## **Technical Bulletin / Safety Alert**

**Unique ID No:** DES2014-TBSA-02

**Subject:** MDR074246DES Inlet Manifold Flametrap Housing Fasteners

**Applicable to:** ALL VLI JUG-A-0 UL/UV Machines with MDR074246DES and MDR074246DES-1

**Figure 1: Excerpt from design registration drawing JHDES-101 Revision C with the intake flametrap housing fasteners identified.**

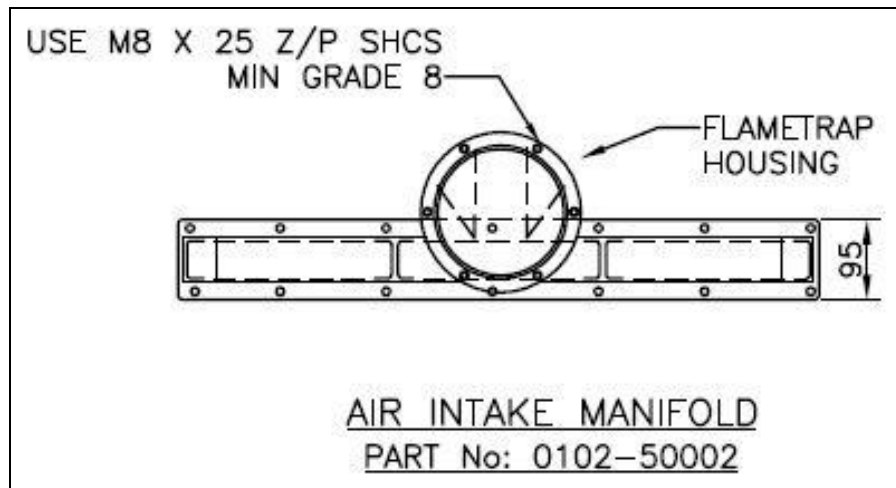
The relevant design registration drawing JHDES-101 Revision C identifies the required fasteners as “M8 X 25 Z/P SHCS Min Grade 8”, refer Figure 1, which are normally installed to blind threaded holes in the inlet manifold flametrap element housing flange.

The fastener requirements specified on the design registration drawing JHDES-101 Rev C, as shown in Figure 1, are accurate for the V3 supercharger installation.

The inlet ducting configuration of the belt driven supercharger installation (V2) results in limited fastener access at the 11 o'clock position (as viewed in Figure 1), and therefore the use of a through bolt with a nut and washer in this location is required.

VLI can confirm that the use of a through bolt at this location on any MDR074246DES or MDR074246DES-1 inlet manifold flametrap housing fixed connection is acceptable, and recommends the use of SAE Grade 8 (or ISO Grade 10.9) fastener components as a minimum.

VLI confirms the use of a through bolt at the 11 o'clock position on any MDR074246DES or MDR074246DES-1 inlet manifold inlet flametrap housing fixed connection is acceptable, and recommends the use of SAE Grade 8 (or ISO Grade 10.9) fastener components as a minimum.
